# Update on 2.3 GHz and 2.6 GHz co-existence analysis reports (Documents 19/59d and 19/59c)

A report from Plum Consulting London LLP

**Reference:** ComReg 19/124c

**Date:** 20/12/2019

Figure 6.1: Composite Interference Contours Calculated for all RurTel BS Receivers (0.1% of time)

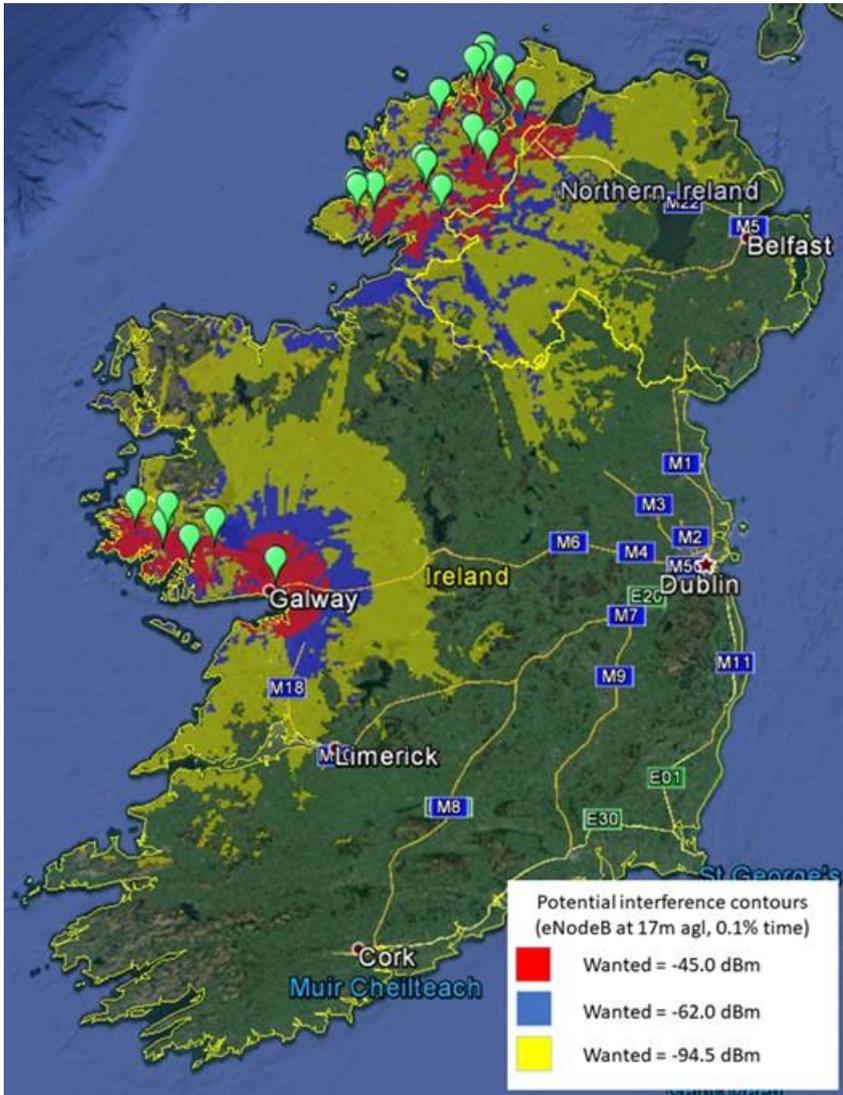
*"The use of this band by Eir to provide RurTel services to a very small number of customers presents a number of issues for the award of the band.... In Figure 10 of the consultation document, ComReg presents exclusion/coordination zones that would be required around the RurTel stations. These are surprisingly large considering the number of customers served, and in fact a substantial part of the geography of Ireland is within the coordination zones."*

*"In the meantime, Eir should be required to reduce the bandwidth used by RurTel to the minimum required. Donegal has the highest number of users at just 77. Even though some repeaters may be required, it seems*

*difficult to justify the use of a full 20 MHz in any of the three locations. Eir should be required to reduce this bandwidth to the minimum necessary, and to justify that bandwidth in each location."*

The sharing analysis is based on available parameters for the RurTel system as described in Appendix A.2 of Document 19/59d. These parameters were derived from data provided by ComReg and Eir<sup>4</sup>.

The analysis has since been updated based on information provided by Eir on 31<sup>st</sup> October 2019, in particular the Kerry RurTel system has been decommissioned and the Galway and Donegal networks revised. Due to the nature of RurTel systems, Plum understand that unless the sites are decommissioned the RurTel bandwidth cannot be reduced and is currently operating from 2307-2327 MHz.

In relation to reducing coordination areas, Plum note further comments were received from Eir on 5<sup>th</sup> December 2019, it was considered by Plum that this information would not impact the output of the modelling completed to date, in particular as no revised equipment parameters were available and this was one key area of uncertainty. The use of detailed technical parameters for specific sites in the modelling may lead to an amendment of the co-ordination zones but currently there is no basis for further amending the outcome of the Plum analysis.

The plots below show the revised composite interference contour taking into account the updated base station information from Eir in the correspondence of 31<sup>st</sup> October 2019 mentioned above. Markers for the individual RurTel base stations have also been included to provide clarity on the location of the RurTel network.
